EDGEWATER REDEVELOPMENT

SUBMITTAL PACKAGE
URBAN DESIGN COMMISSION

JANUARY 13, 2010

DESIGN EVOLUTION – INTEGRATION OF UDC COMMENTS

BUILDING SETBACK

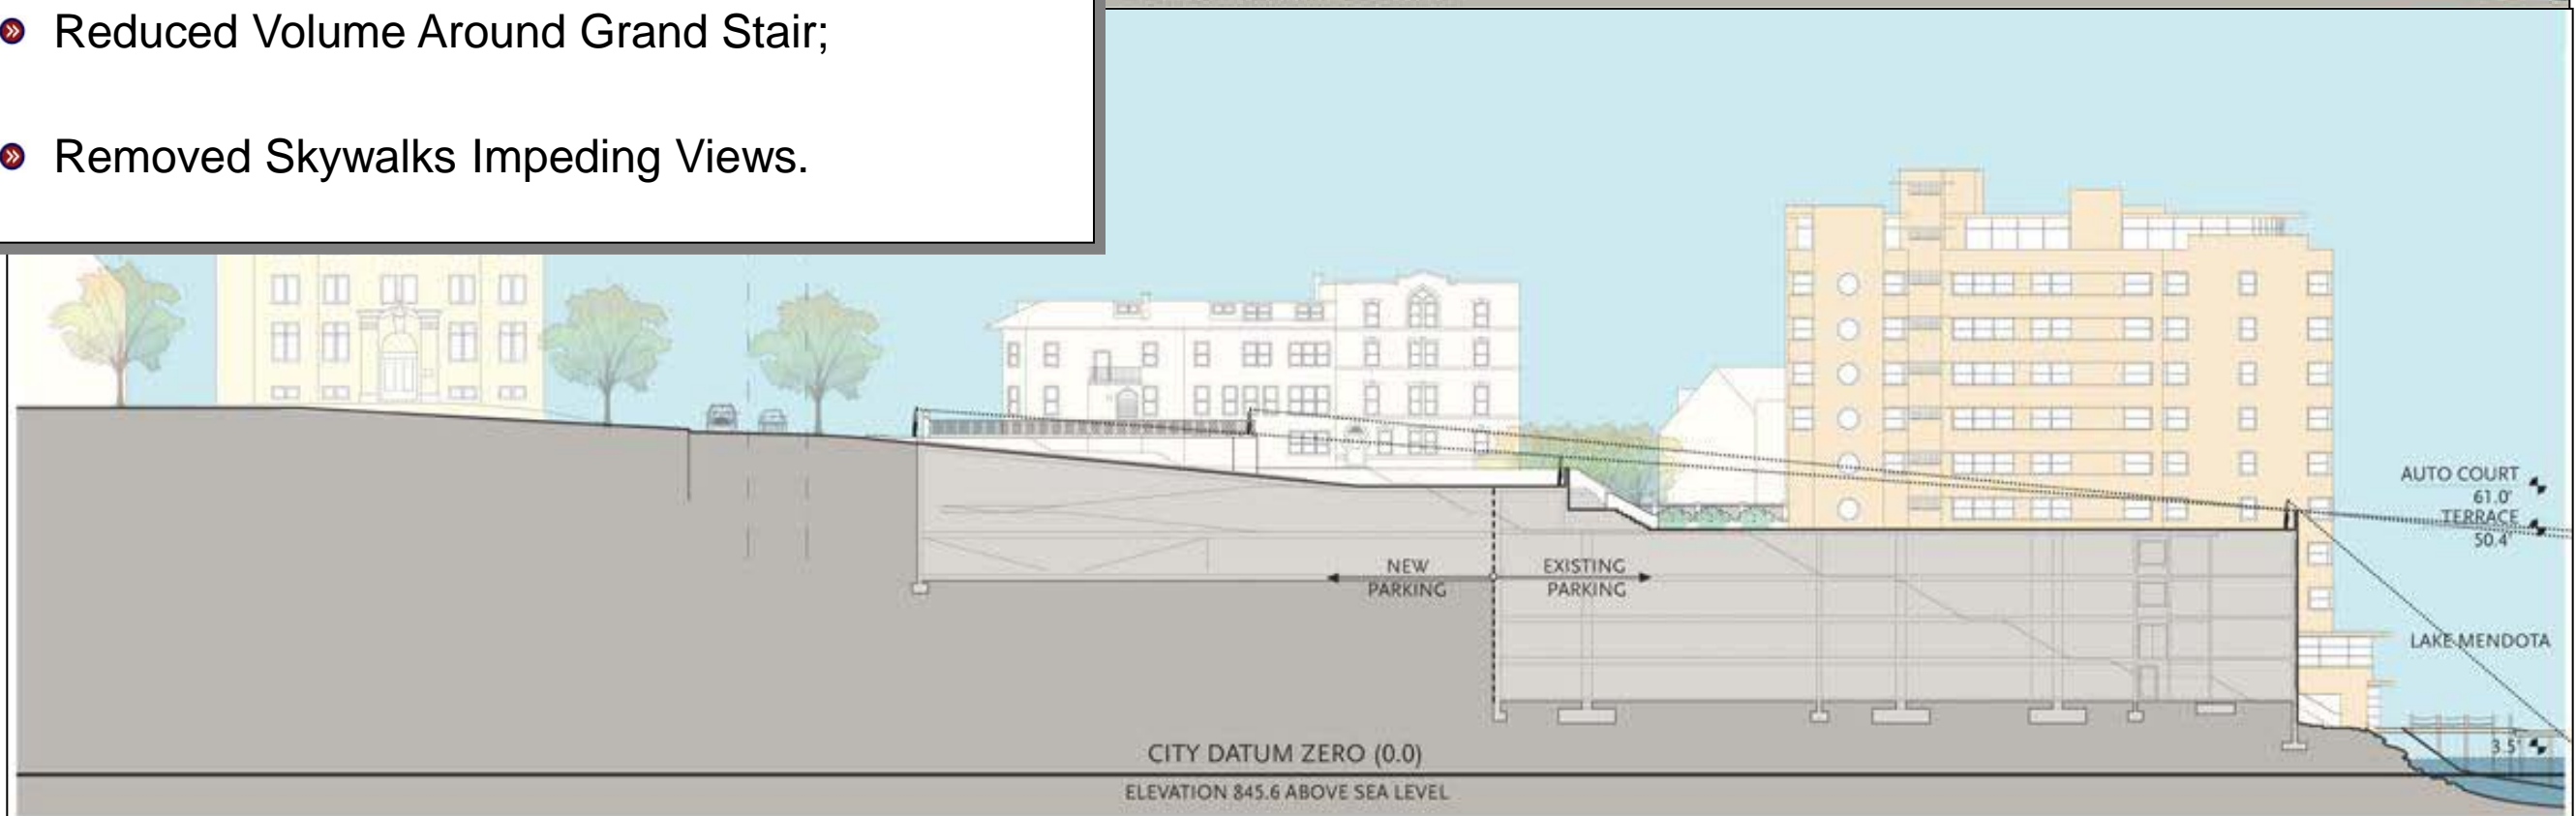
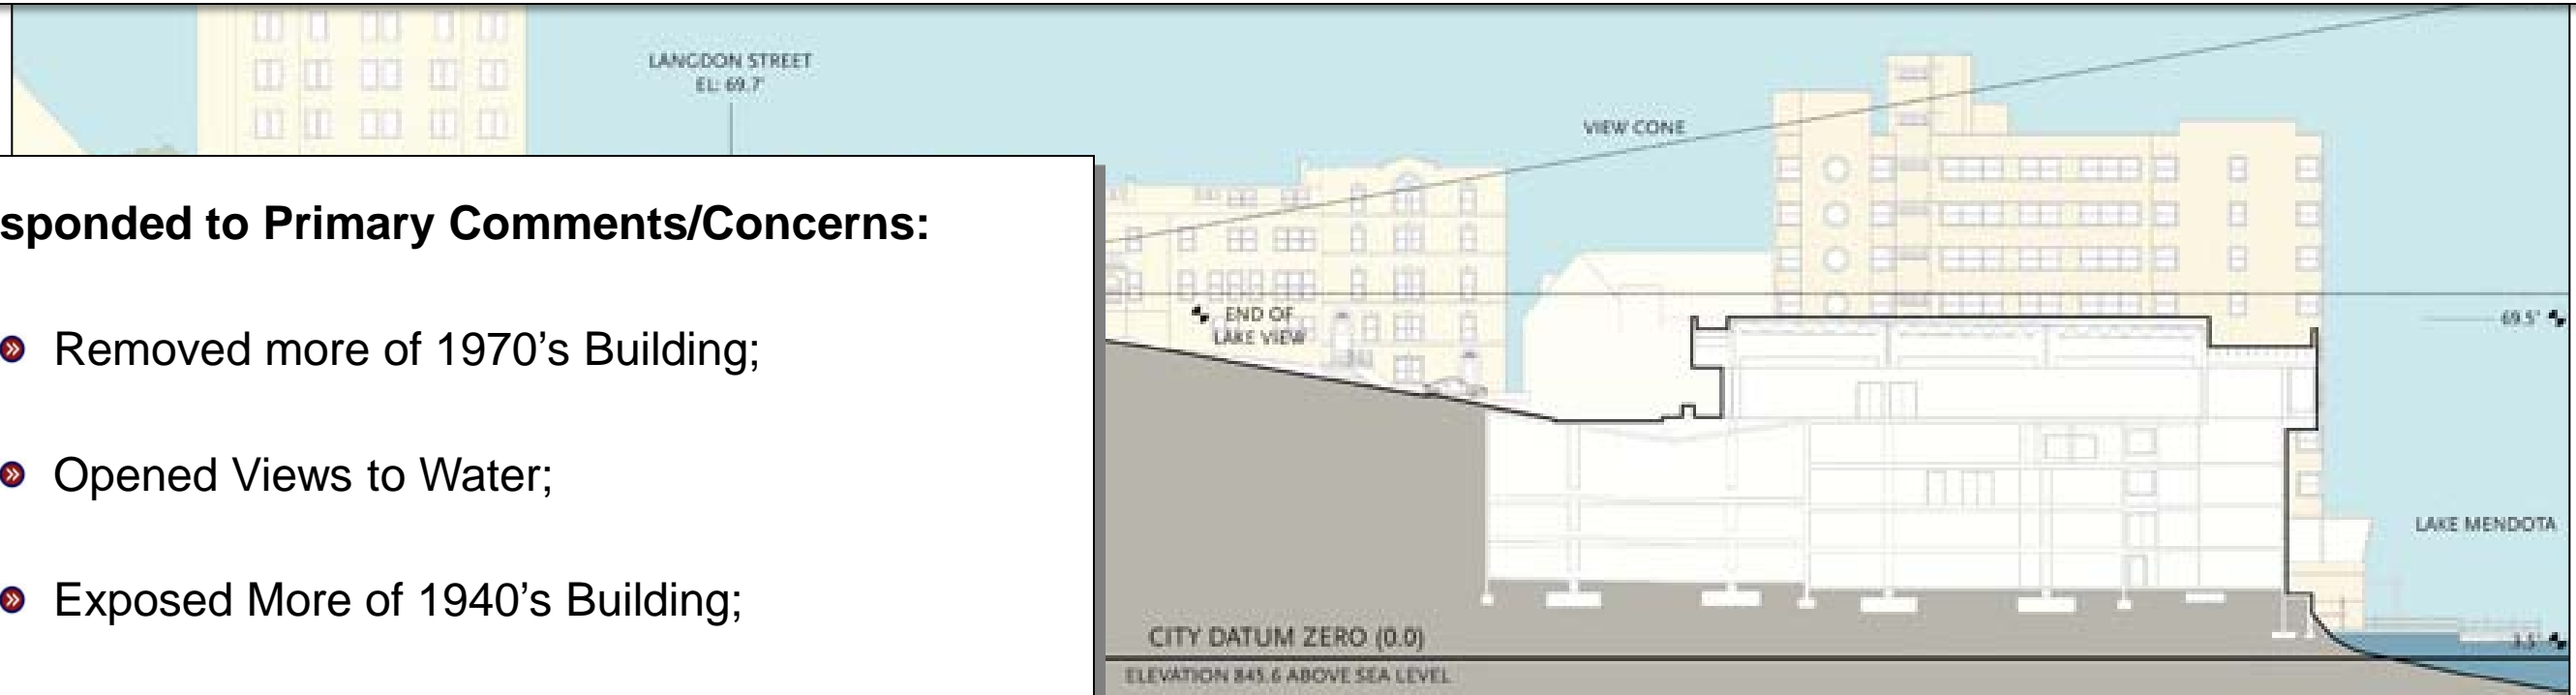
INFORMATION REQUEST: Explain the building setback in relation to Wisconsin Avenue and Langdon Street.

- The tower is setback 42'-5" feet from Wisconsin Ave;
- Setback is consistent with build-to line on Wisconsin Ave;

- The tower is setback 30'-4" from Langdon Street;
- Setback is consistent with build-to line on Langdon Street.

VIEWS TO/FROM LAKE MENDOTA

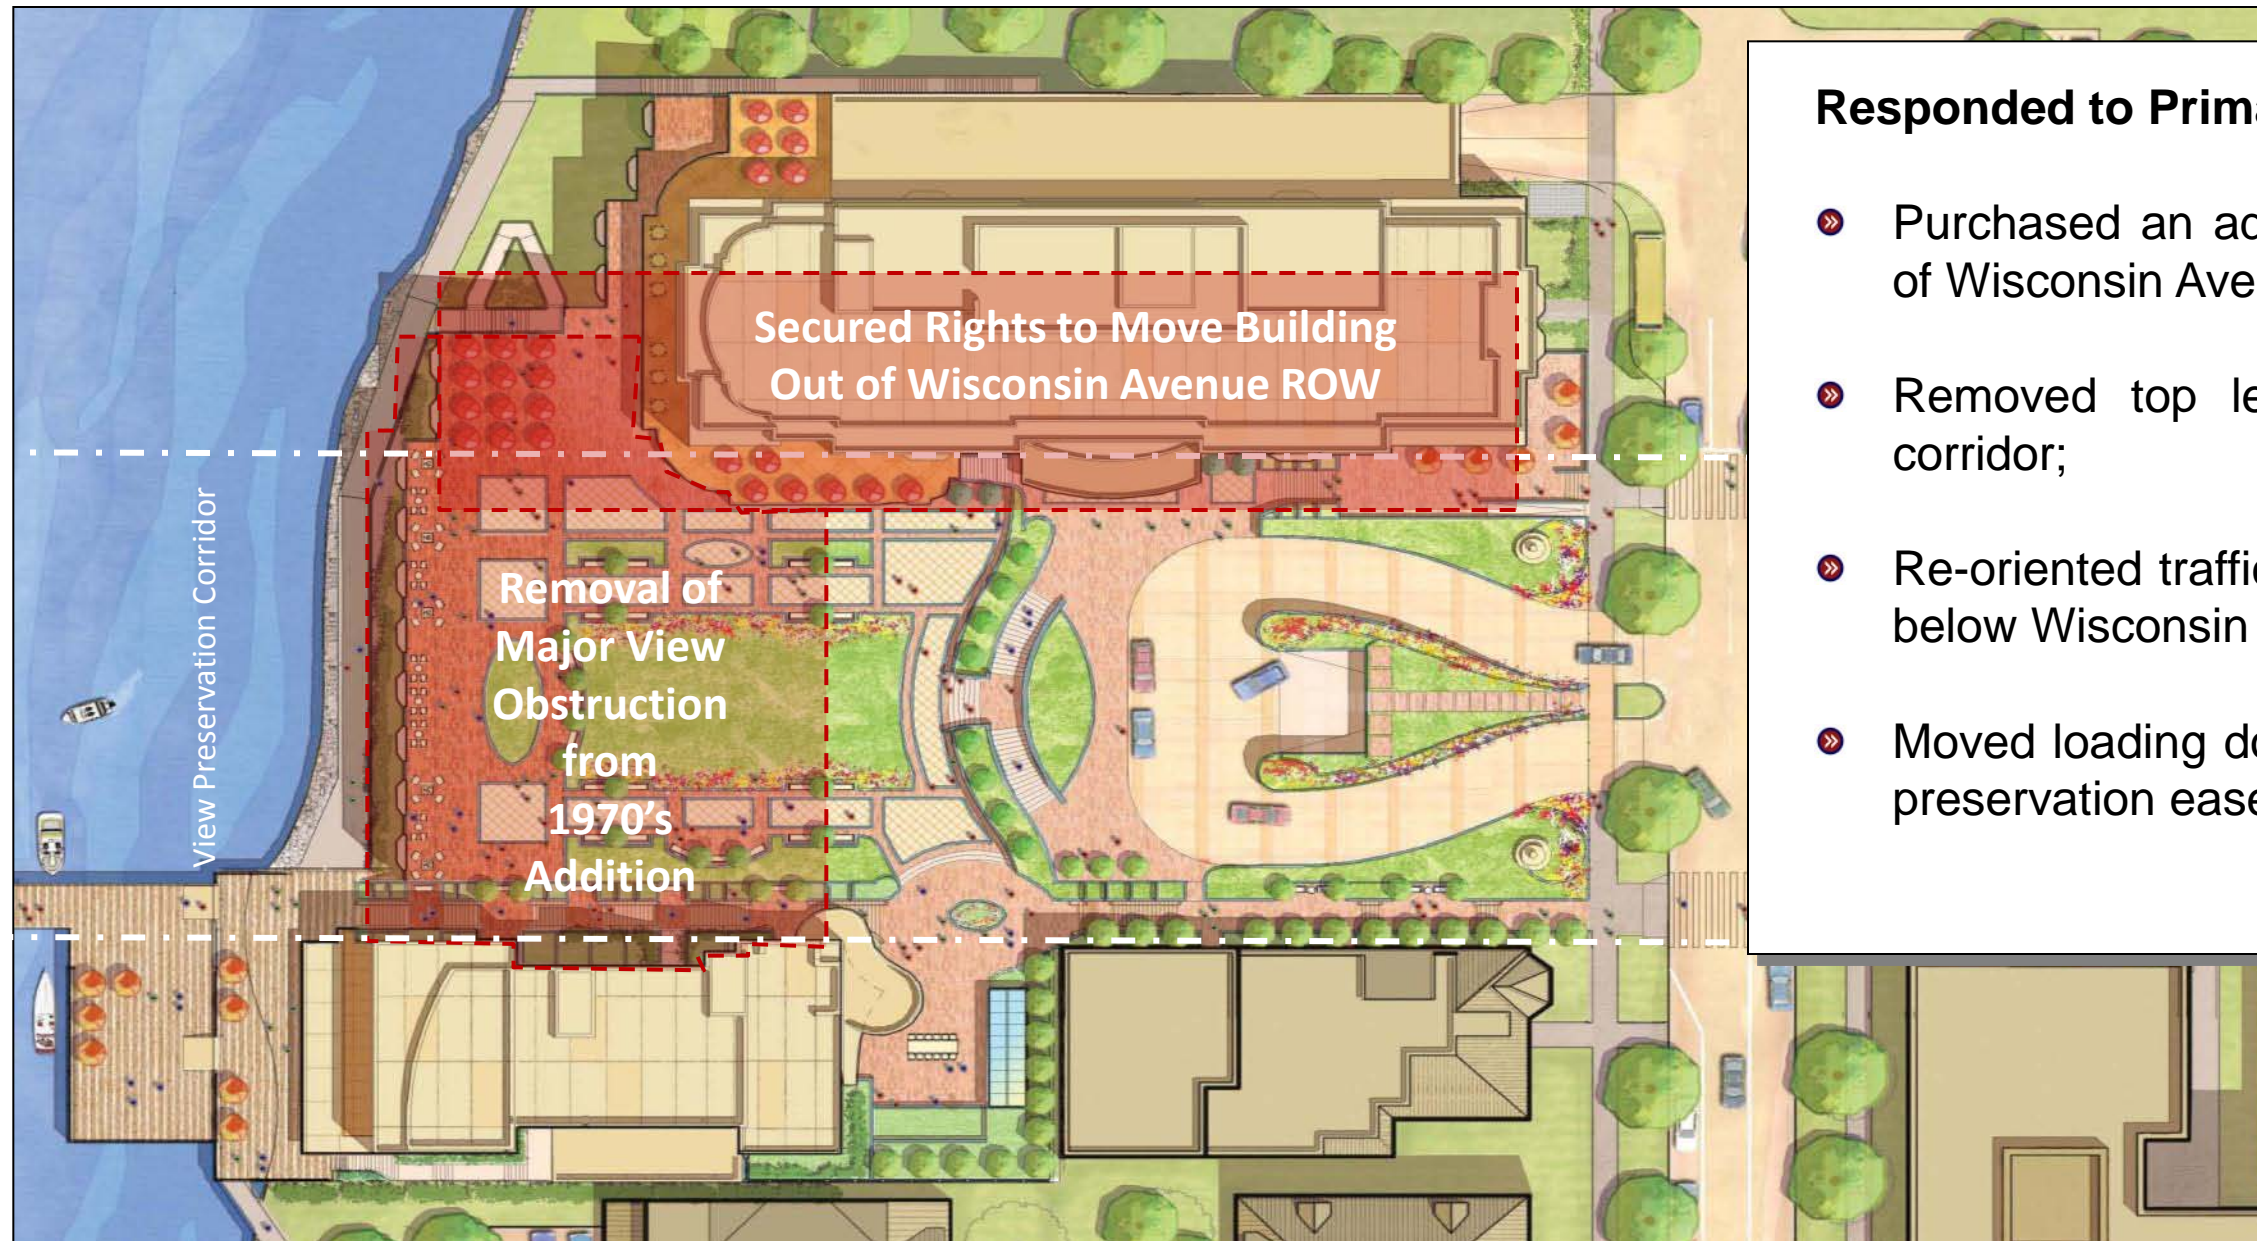
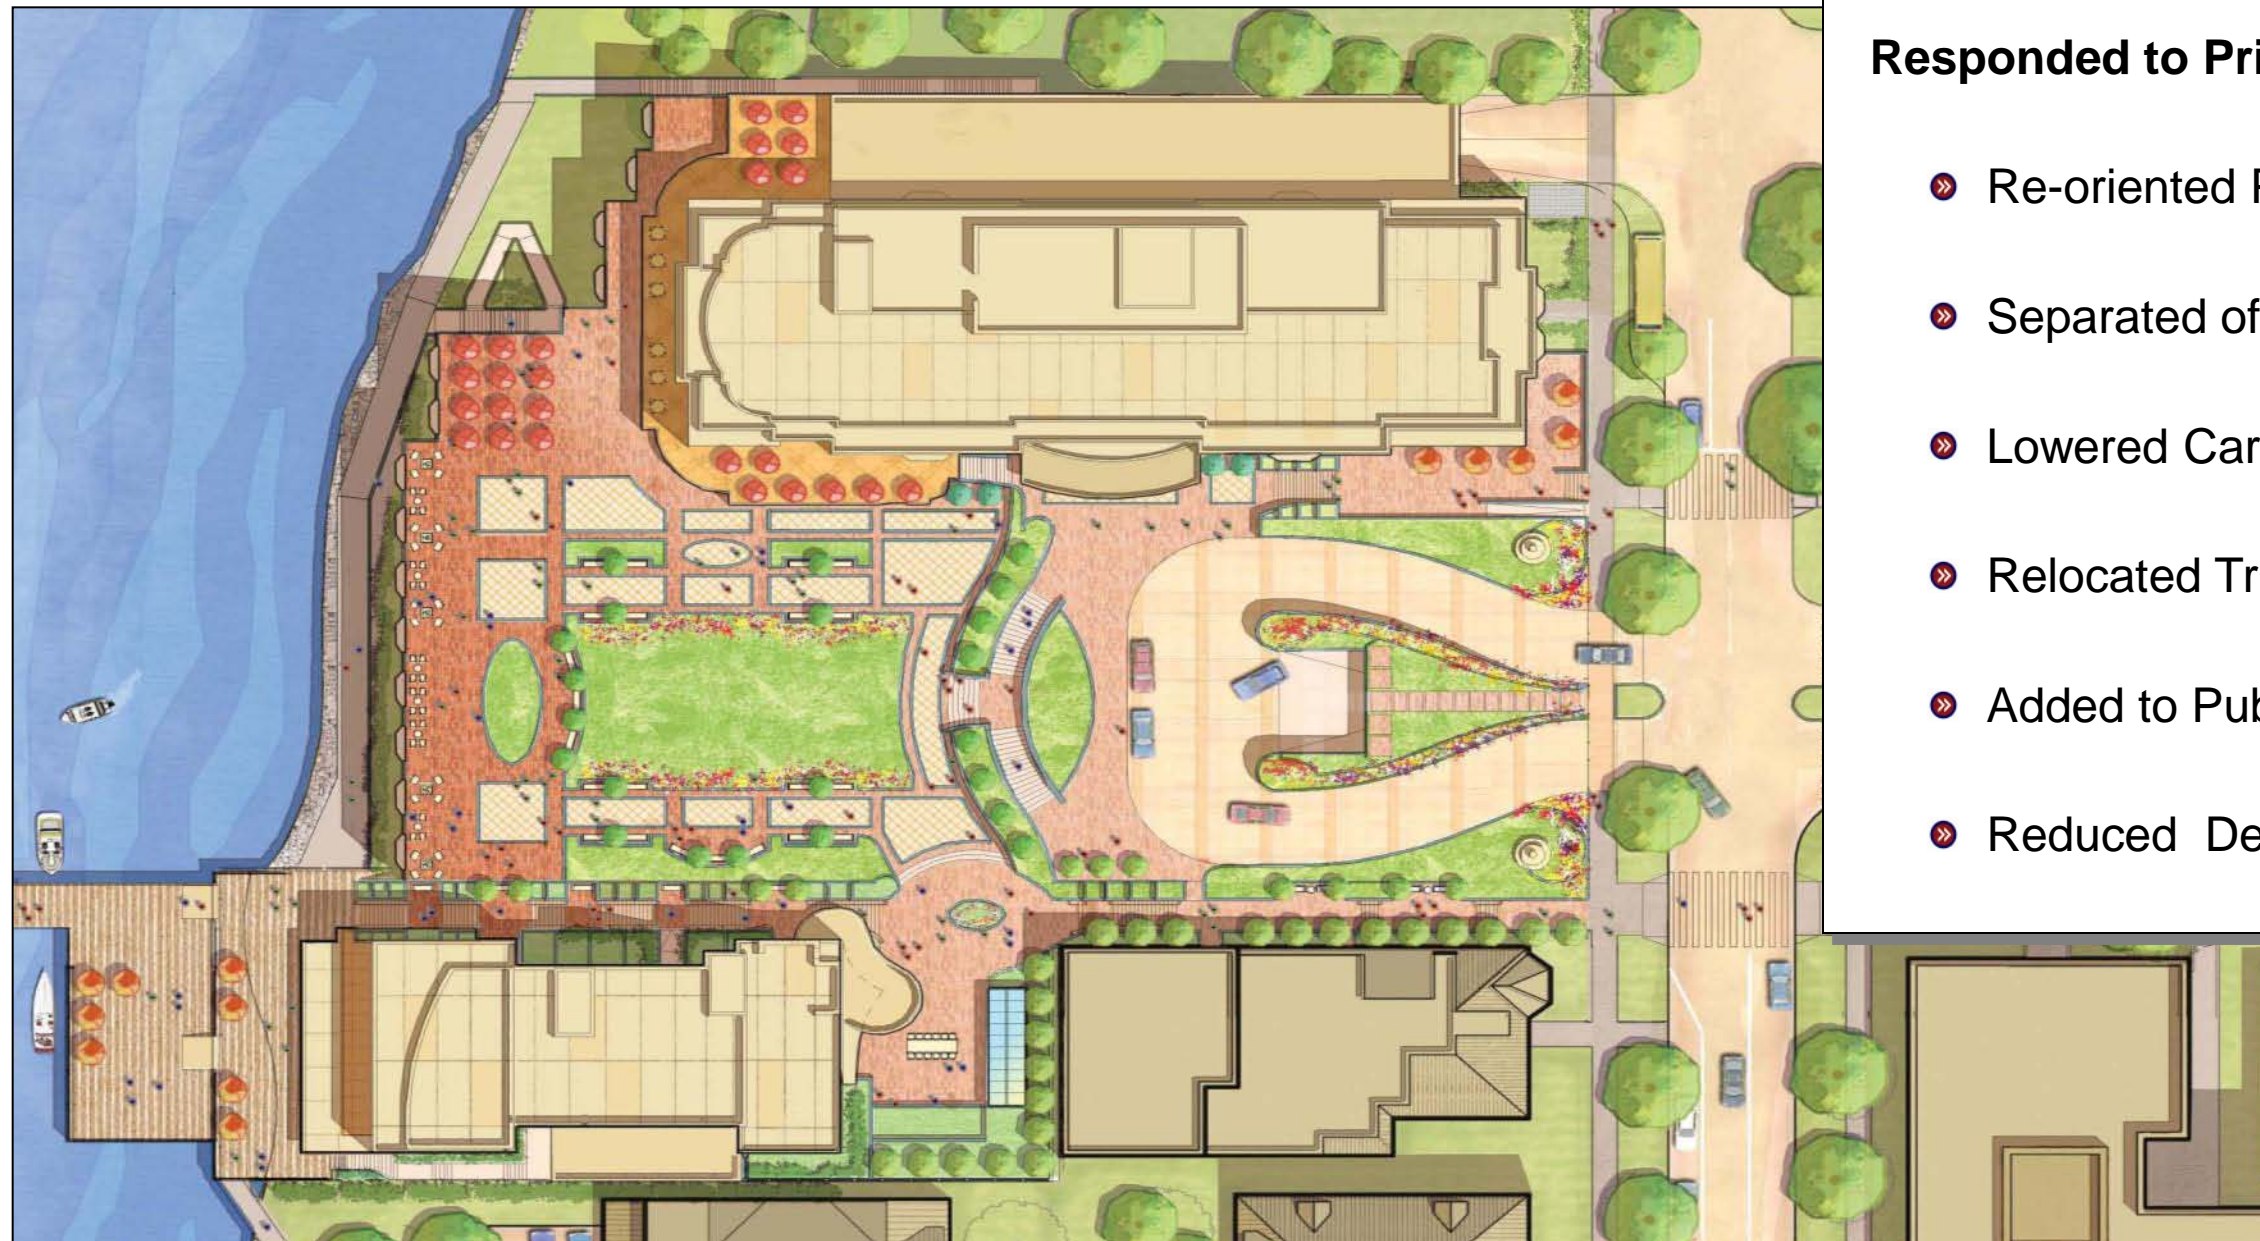
INFORMATION REQUEST: Explain primary changes in design that have allowed for opening of view corridor

- Purchased an additional 60 FT to move building out of Wisconsin Avenue right-of-way;
- Removed top level of 1970's building from view corridor;
- Re-oriented traffic patterns to lower cars and drop-off below Wisconsin Avenue view corridor;
- Moved loading dock and bus drop-off outside of view preservation easement.
